Docket Item # 3  
BAR CASE # 2010-0074

BAR Meeting  
May 26, 2010

**ISSUE:** Alterations  
**APPLICANT:** Julia Nierad  
**LOCATION:** 317 North West Street  
**ZONE:** RB/Residential

**BAR CASE #2010-0074**

Figure 1. Plat – Showing proposed shed, fence and gate

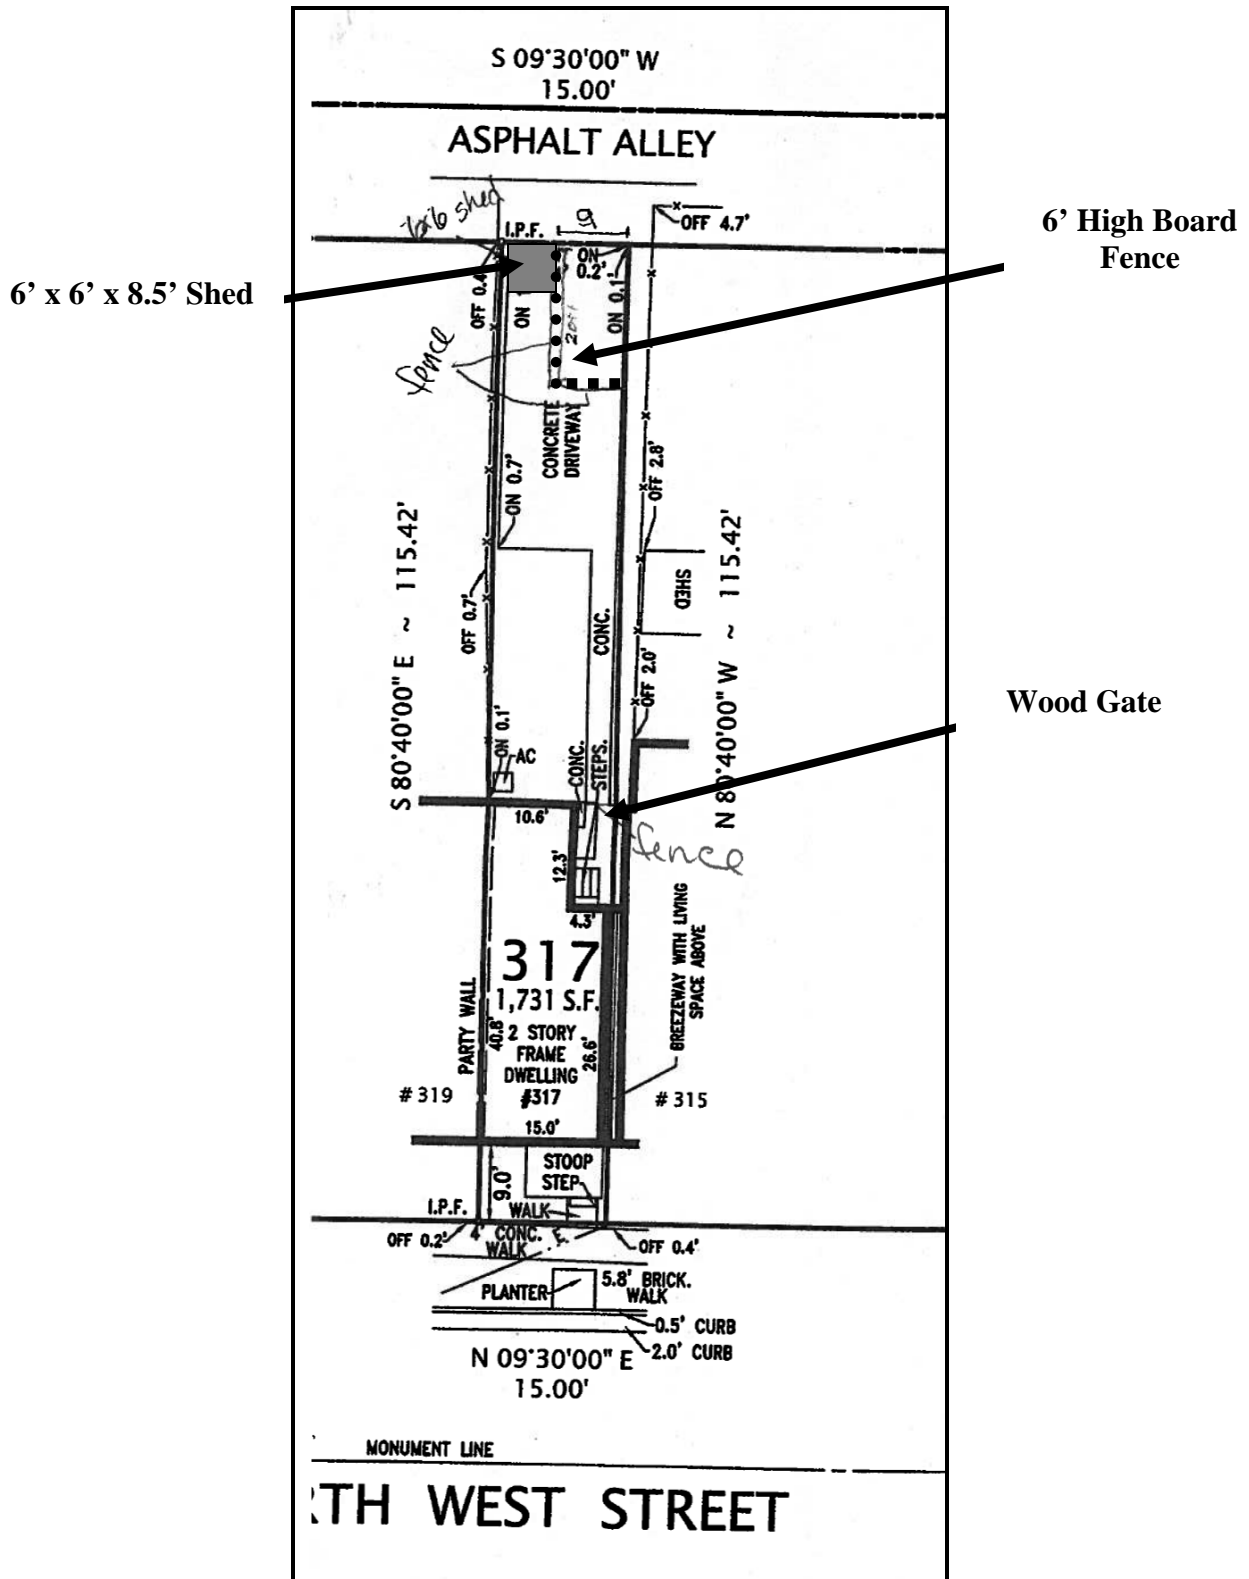
1. Construct a new, wood 6' high board-on-board fence in the rear of the property as shown on the attached plat (page 6).
2. Construct a new, 6' x 6' x 8.5' wood, custom built shed at the rear property line. The shed is to be clad in 1 x 6 horizontal wood siding and sheathed with an asphalt shingle roof.
3. Construct a new, 2.5' x 6' wood gate at the terminus of the walkway along the side of the house which leads from the front to the rear yard.

The applicant was removed from the previous docket to address zoning related issues inherited with the purchase of the property. The subject property currently has a very large concrete pad in the rear yard. The RB zone requires each lot to provide a minimum of 800 square feet of open and usable space. The pad, as it is currently designed, is completely accessible for parking negating its ability to be calculated as open-space. However, if the applicant reduces the property's parking spaces by enclosing a portion of the rear yard and the concrete pad with a fence, the amount of open space, as defined by the *Zoning Ordinance*, increases to satisfy the zoning staff's concerns (at grade patios may be included in open-space calculations). The current proposal includes this fence installation.

The proposed fencing will be replicating the current fencing utilized by the flanking neighbors, a 6' high, board-on-board, fence. Although the *Guidelines* dictate that fencing must be painted or stained, Staff is recommending that this condition not be imposed on this applicant as the

Figure 4. Photo Mock-up of Proposed Shed

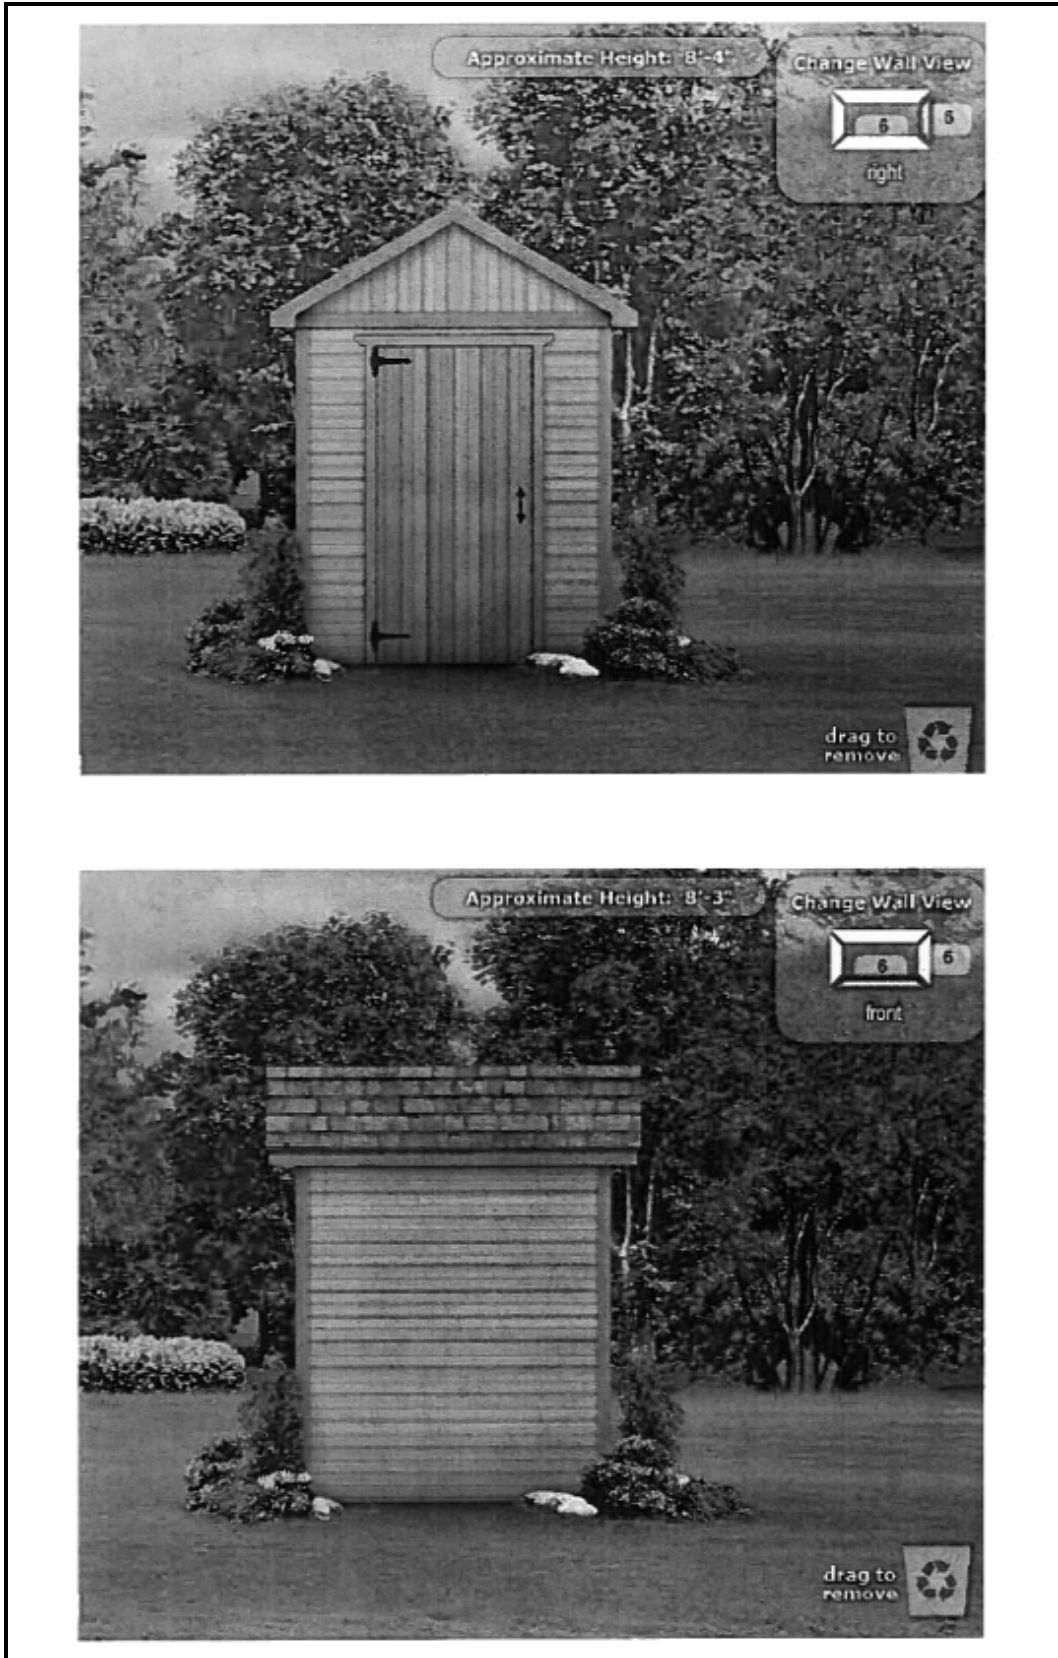
The shed is being proposed at the rear property line and is in scale and proportion with sheds and other outbuildings within the historic district. The proposed cladding material matches the 1 x 6 wood horizontal siding and paint color on the house – consistent with the recommendations in the *Design Guidelines*.
